Subject: FW: AB/88/19 Gasworks Site, Ford Road, Arundel

APPLICATION NO: AB/88/19/PL

Description of Works: 38 No residential apartments (9 No 1-bed units & 29 No. 2-bed units) along with access, off-street parking, amenity space & enhancements to the local footpath network.

LOWER GROUND FLOOR PLANS

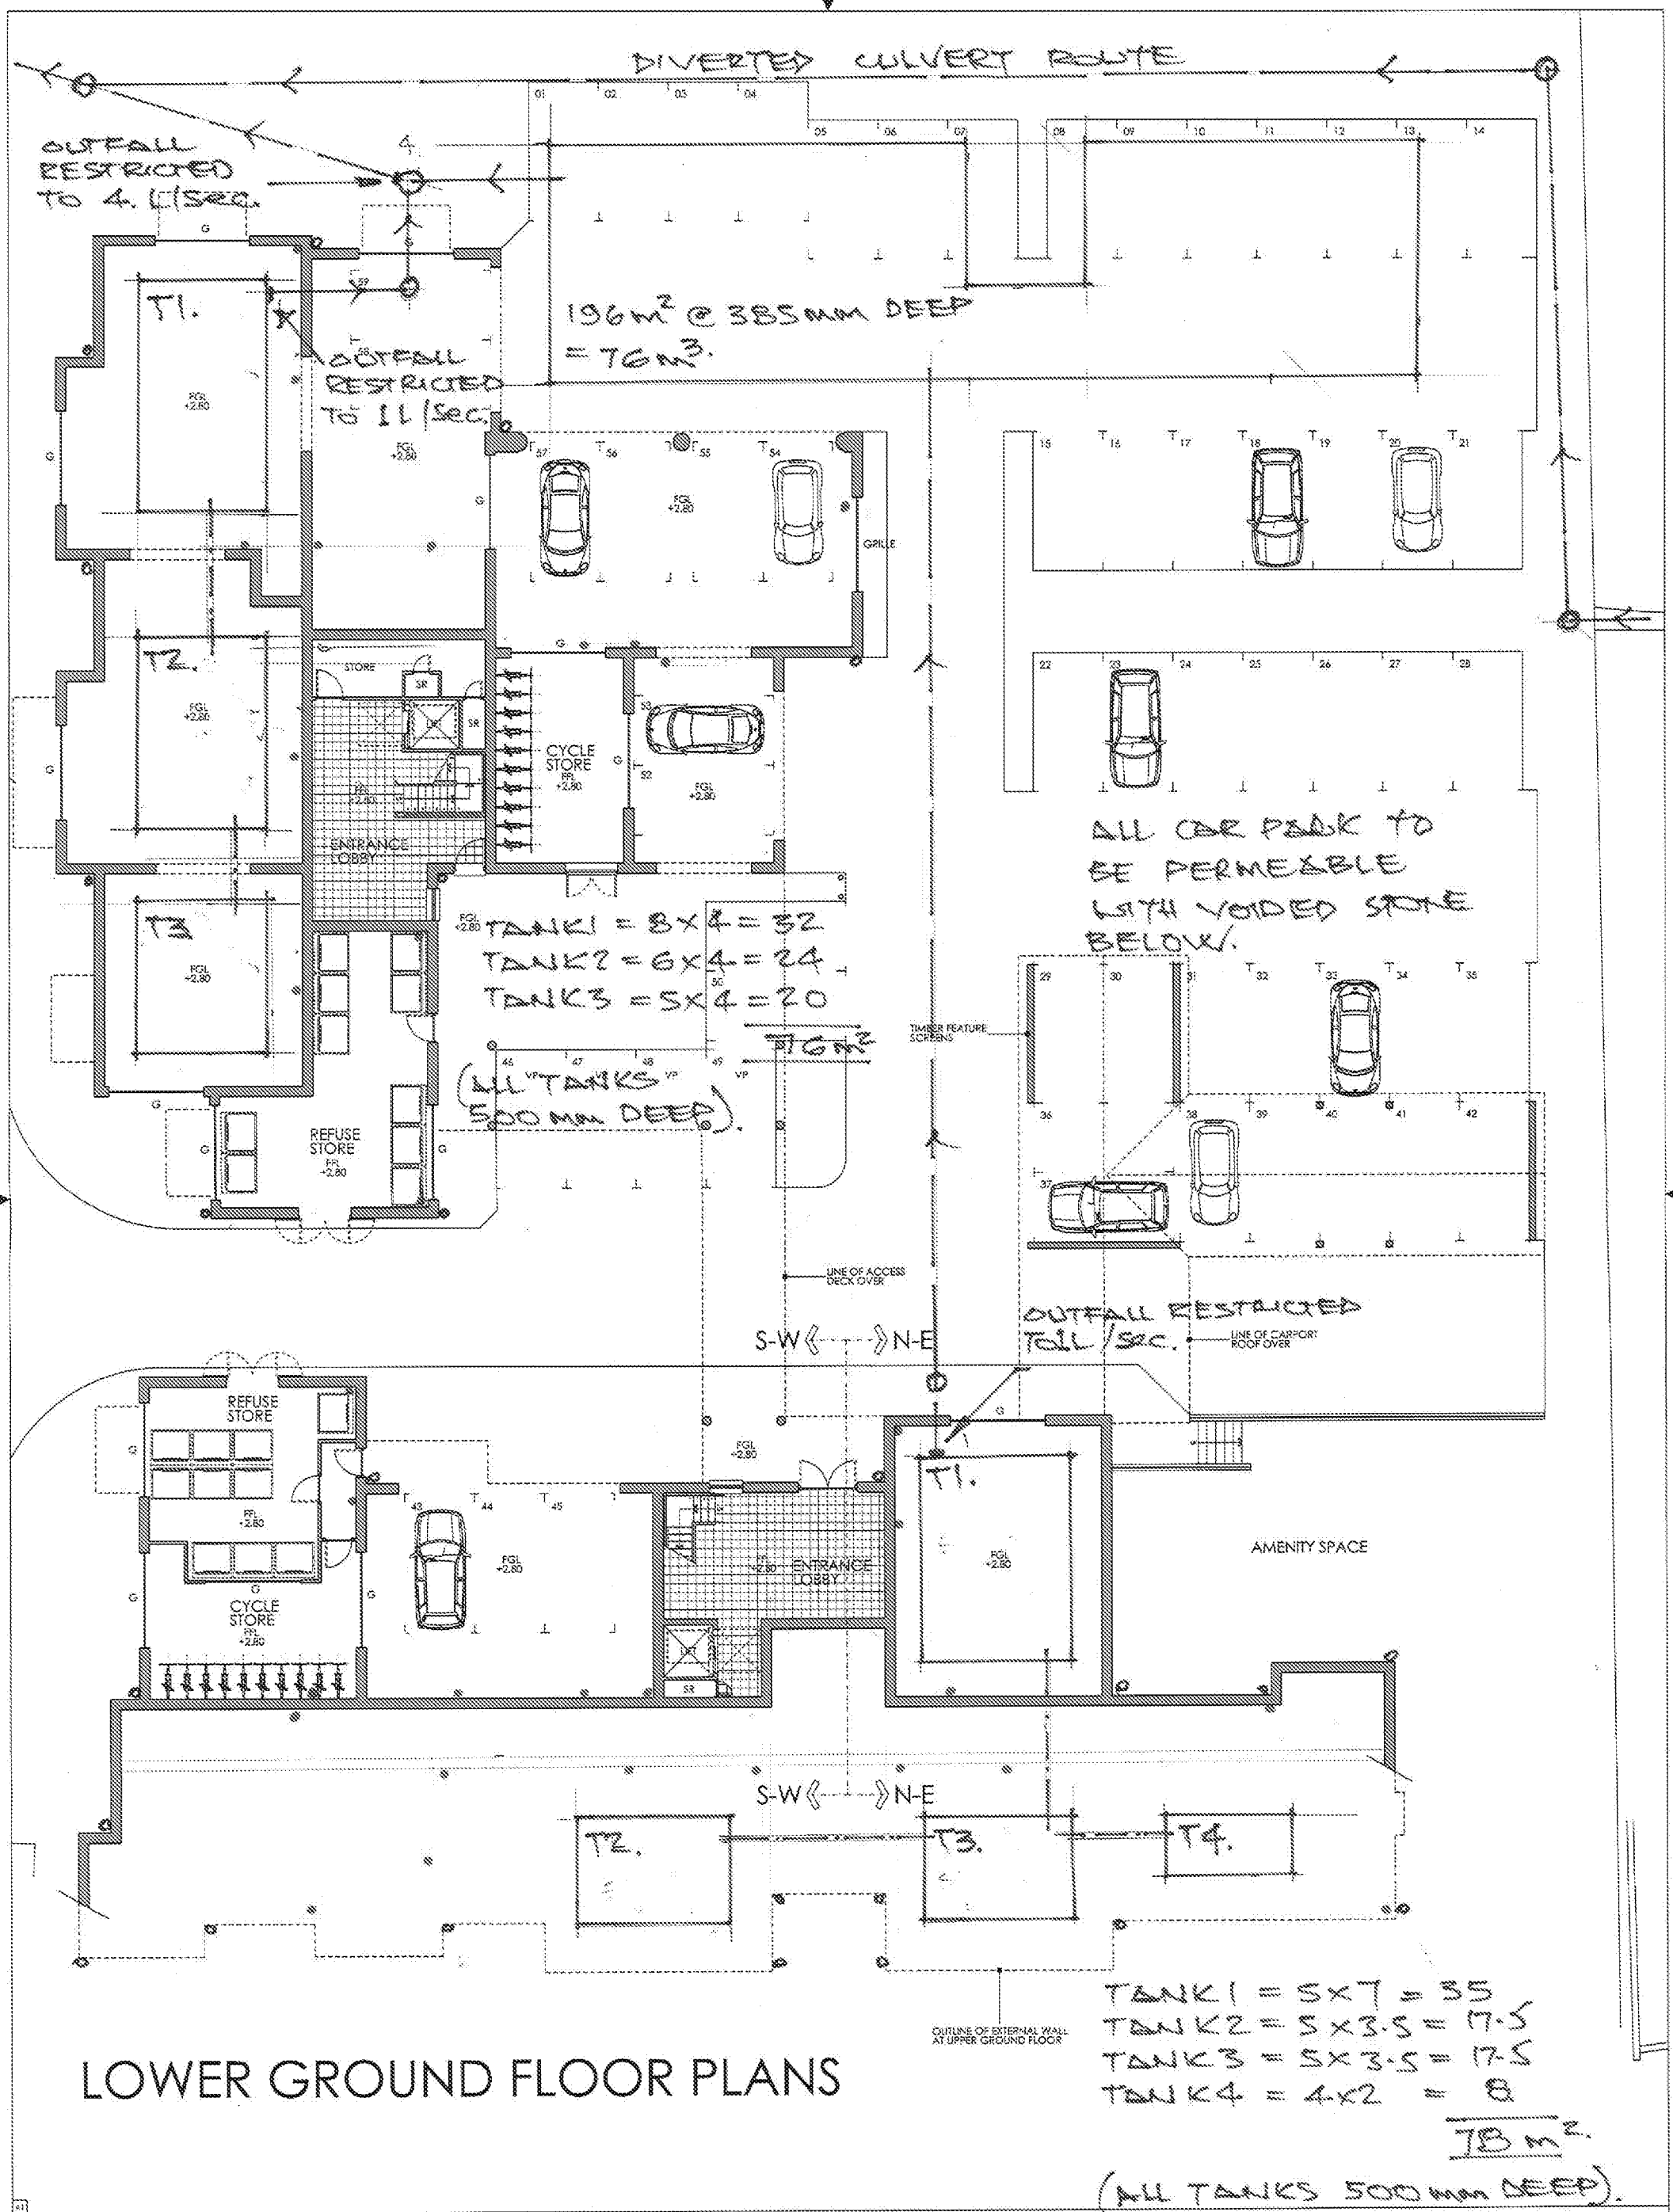
3. I also enclose previous comments from West Sussex County Council (the Lead Flood Authority) highlighting similar concerns.
4. The latest proposals from the applicants engineers are enclosed and still do not resolve all the issues in item 2 above. The current scheme involves installing storage tanks (to store roof water) just below first floor level

and above the predicted 1 in 100 year (+ 105% allowance for climate change) fluvial flood level . These tanks would then discharge into a below ground drainage system that also serves ground level car parking areas (and within the fluvial flood plain). It is unclear whether the proposed system has been designed to accommodate a 1 in 100 year storm event + 40% climate change allowance or given due consideration to the impacts of tide locking downstream. Maintenance of those tanks and potential blockage issues with their restricted outlets are also considered to be operational issues. Nevertheless, the fact that the storage tanks will discharge into a below ground drainage system that would itself be submerged/full during the fluvial flood event, is not an acceptable or sustainable solution. For these reasons and those mentioned in item 2, we will maintain our objection. If conditions were applied as mentioned by my colleague, then it is very unlikely that applicant will be able to satisfy those relating to surface water disposal, since there currently appears to be no sustainable/workable solution given the site constraints.

- To accommodate proposed roof drainage, the proposal can be amended to incorporate raised tanks within the undercroft areas as shown on the attached plan. This will therefore remove this storage from the floodplain. The storage tanks are set above the flood level with an allowance for support and clearance over the top. There is also access to all the tanks from the sides for installation, repair and replacement if damaged. The tanks will need to be sectional to allow this to work. The calculations attached show how the areas are worked out and the storage tanks sized. The roof water from the front and rear blocks is collected into the tanks below the respective buildings. The outfall from the tanks is then restricted to 1l/s before discharging below ground.
